MAG Standard Specifications and Details Committee
TENTATIVE AGENDA
July 13, 2011

MEETING MINUTES FROM THE
MARICOPA ASSOCIATION OF GOVERNMENTS
STANDARD SPECIFICATIONS AND DETAILS COMMITTEE

Date: June 1, 2011
To: MAG Specifications and Details Committee
From: Scott Zipprich, Town of Buckeye Representative
Subject: Detail 423, 424, 523-1, 523-2
Case: 11-13

SUBJECT: Modifications to Detail 210: Residential Speed Hump

DETAIL NO.
423-1

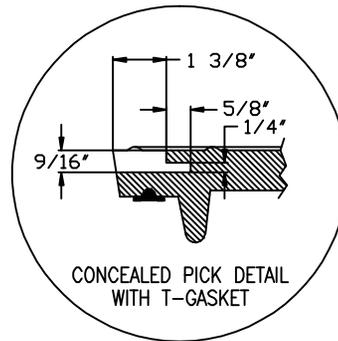
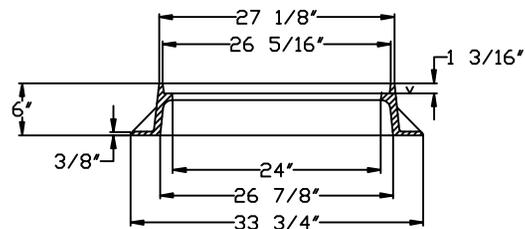
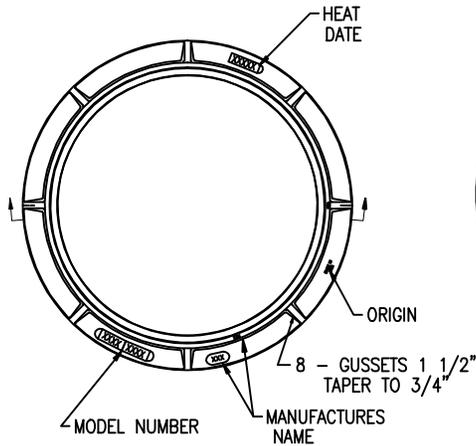
PURPOSE: To replace the current manhole frame and cover details with updated details of products that are currently being manufactured. This also includes referencing the proper Class and AASHO references.

REVISION: The revisions will consist of replacement details 423-1, 423-2, 424-1, 424-2, 523-1 and 523-2.

DETAIL NO.		STANDARD DETAIL ENGLISH	DRY BARREL FIRE HYDRANT INSTALLATION	REVISED 04-27-2011	DETAIL NO. 360-1
360

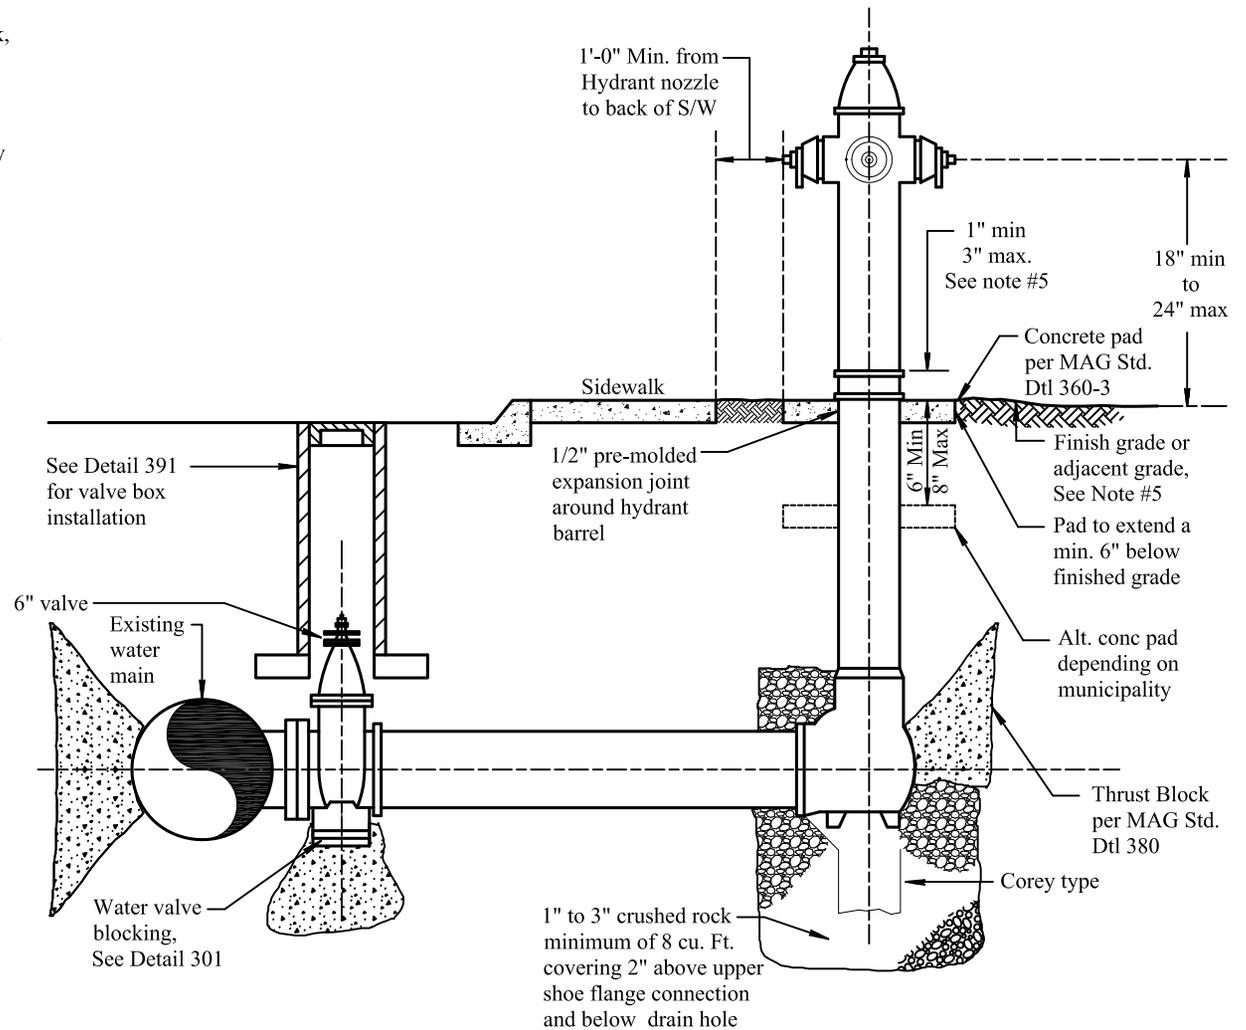
Craig Sharp passed out new details 360-1 (dry barrel), 360-2 (wet barrel), and 360-3 (installation details) to replace the current MAG detail 360. The wet barrel detail is based on the detail from Avondale, and the dry barrel detail updates the current MAG 360. Mr. Sharp said Scott Zipprich plans to introduce these as a case at the July committee meeting. He also said the pipe between the water valve and hydrant is noted as ductile iron. Mr. Badowich described the advantages and disadvantages of both types. He said the dry barrel hydrants sometimes become difficult to open and can break the linkage down to the valve below grade. He said a check valve now will automatically shut off the water in a wet barrel hydrant if it is hit. Detail 360-3 shows the location of thrust blocks (as currently shown on MAG 360) and adds a pad detail.

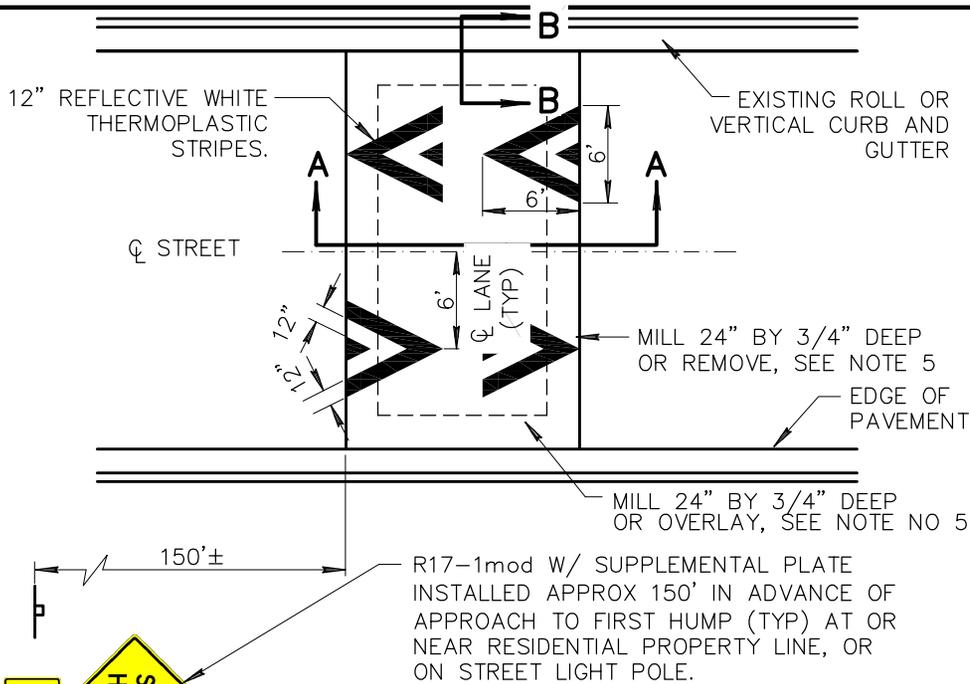
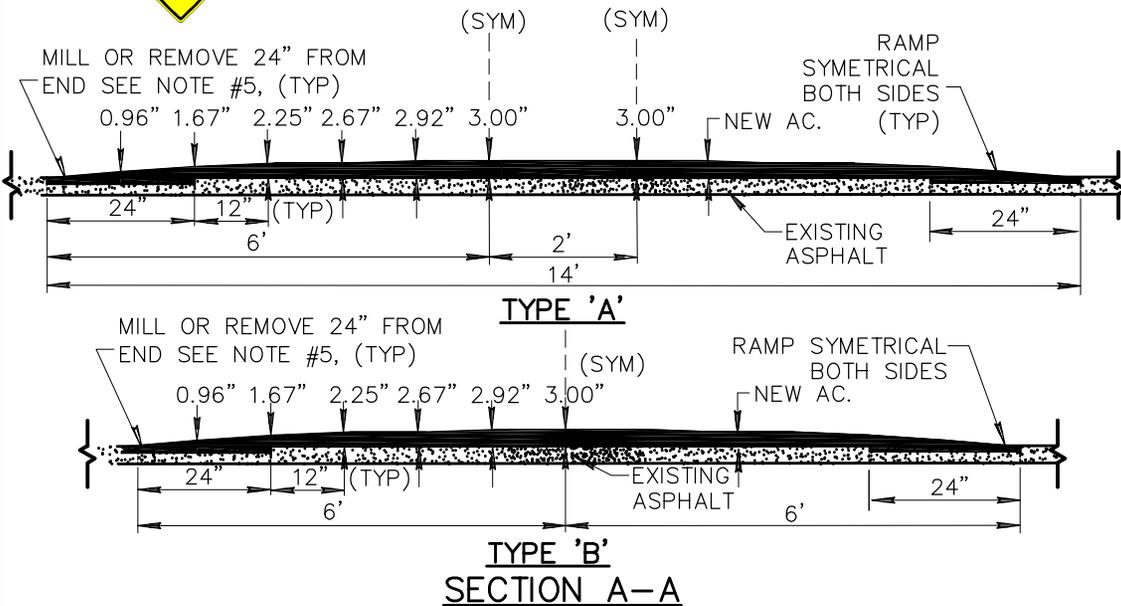
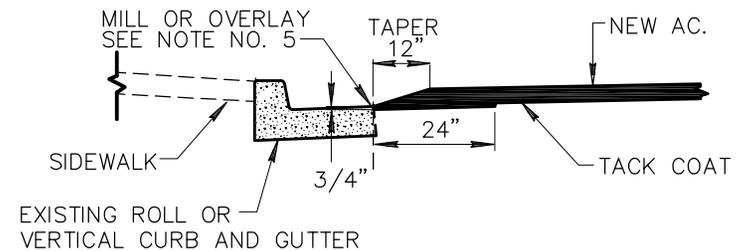
The current MAG Detail 210, Residential Speed Hump has become non-compliant with MUTCD marking requirements (see below). The point of the each chevron marking should face toward oncoming traffic.

The draft changes to Detail 210 include:

- Markings in accordance with MUTCD Figure 3B-29, Option B.
- Calling out 12" thermoplastic markings.
- Calling out the use of 1/2" asphalt mix.
- Clarifying the mill surface in the section views.
- Consolidating the profile requirements into one note.
- Creating two types: Type 'A' - 14' and Type 'B' - 12'.
- Specifying advance signing for the hump series.
- Locating the chevrons close to centerline to avoid obscuration by parked cars.

Also, we'd like to note that the alternate installation longitudinal joint method consisting of tapering the AC profile may be problematic to achieve.
